Application Reference: 4/25/2342/0F1

Site: THE WHITEHAVEN ACADEMY, CLEATOR MOOR ROAD CA28 8TY

Proposal: Variation of condition 2 (plans) for variation in design of planning application 4/24/2149/0F1 proposed dining & changing room extension

Sport England Reference: PA/25/NW/WAF/70574

Above: Current layout plan

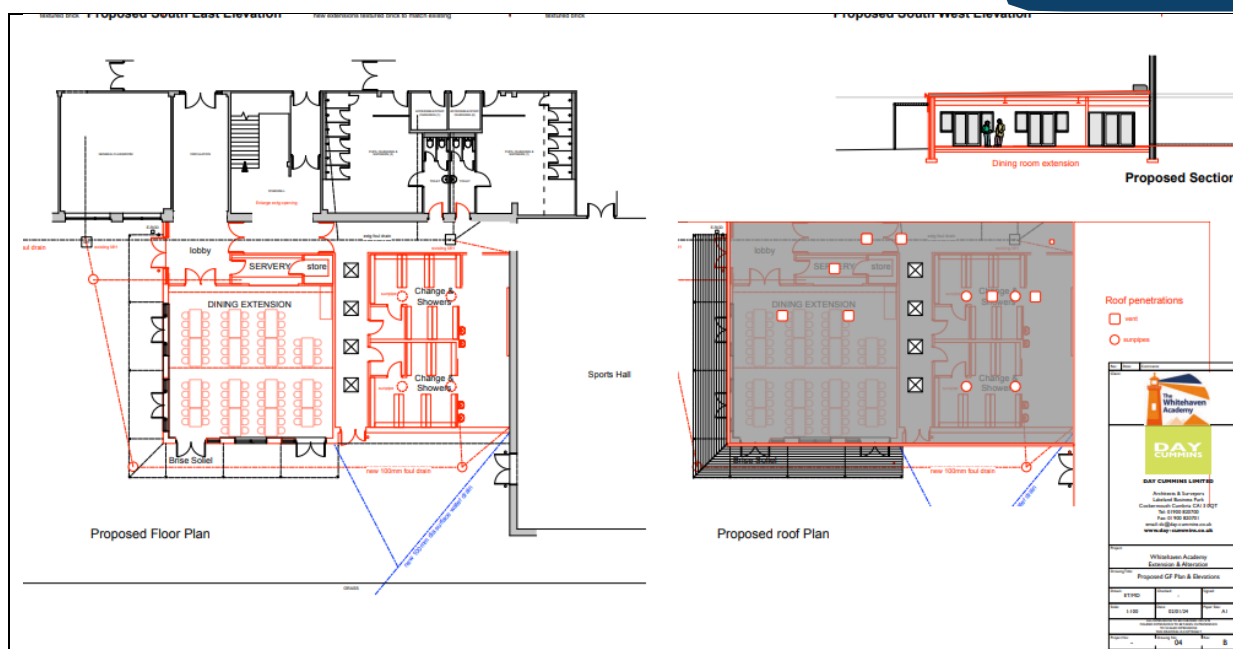
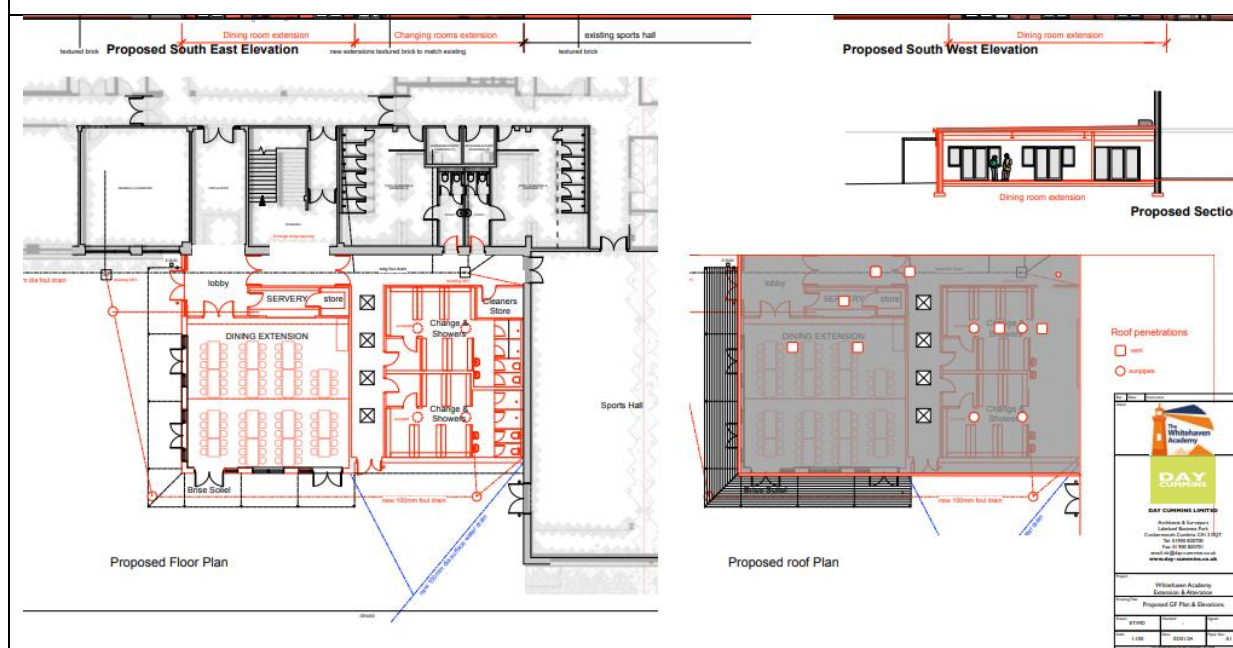
Sport England notes that the additional and updated information includes amendments to the layout of the changing block element of the proposal. The location of the dining extension and changing block have not altered since Sport England previously commented:

- *The new amendments are compliant with FF guidance and align with the existing site plan.*
- *FF notes that an accessible WC does not appear on the submitted plans, and the school should ensure provision is made so that users have appropriate access where required.*

However, the FF have also commented that an accessible WC does not appear on the submitted plans, and the school should ensure provision is made so that users have appropriate access where required.

Sport England would be grateful if a copy of our comments can be forwarded to the applicant so that they can consider amending the design and clarifying the issues the comments raised by the FF above.

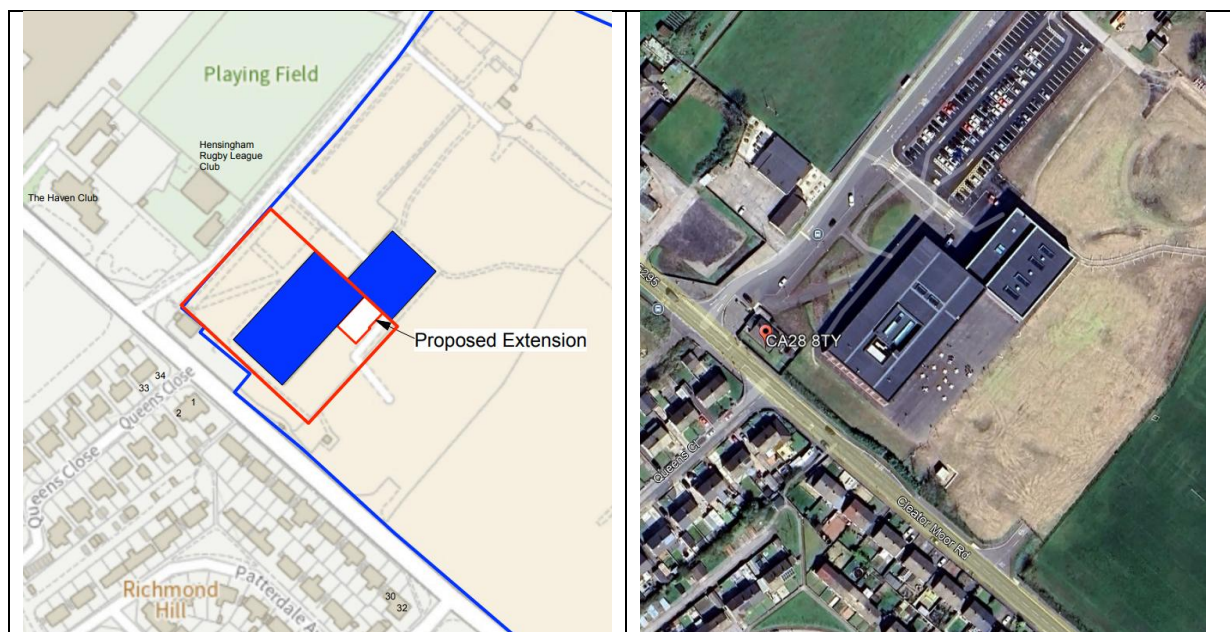
- *Whitehaven Academy has three grass pitches on site. However, the proposed extension is planned for the large tarmac playing area, with a substantial soft play area situated between the grass pitches and the proposed extension. Therefore, there would be no impact on the football provision on site.*
- *The changing rooms overall appear compliant with general guidance, with no welfare concerns regarding line of sight. However, FF raises questions around the potential for additional toilet provision as no new is proposed and only four existing are shown to service four changing rooms, and requests greater clarity on the placement of showers and the gap shown to the north of the diagram, as the room is titled changing and showers but no showerheads are shown, therefore compliance cannot be determined if showers are planned.*

- *If amendments are made, FF would expect any design changes regarding the showers to align with the existing site plan as they are compliant, i.e. cubicles. For any other improvements or changes, FF recommends referring to our changing room guidance available on the website.
<https://footballfoundation.org.uk/changing-pavilion-design-key-considerations>*
- *Overall, as this is an extension of an existing operating facility—and given the school's continued growth and success over the years—the added changing facilities will support football usage on site. The current proposal is largely acceptable, with some minor clarification requirements.*

Some of the Governing Bodies have raised some design issues and matters of clarification in relation to the layout of the changing rooms and matters to consider such as the displaced playground use.

Sport England would be grateful if a copy of our comments can be forwarded to the applicant so that they can consider amending the design in accordance with the comments raised by the Governing Bodies above.
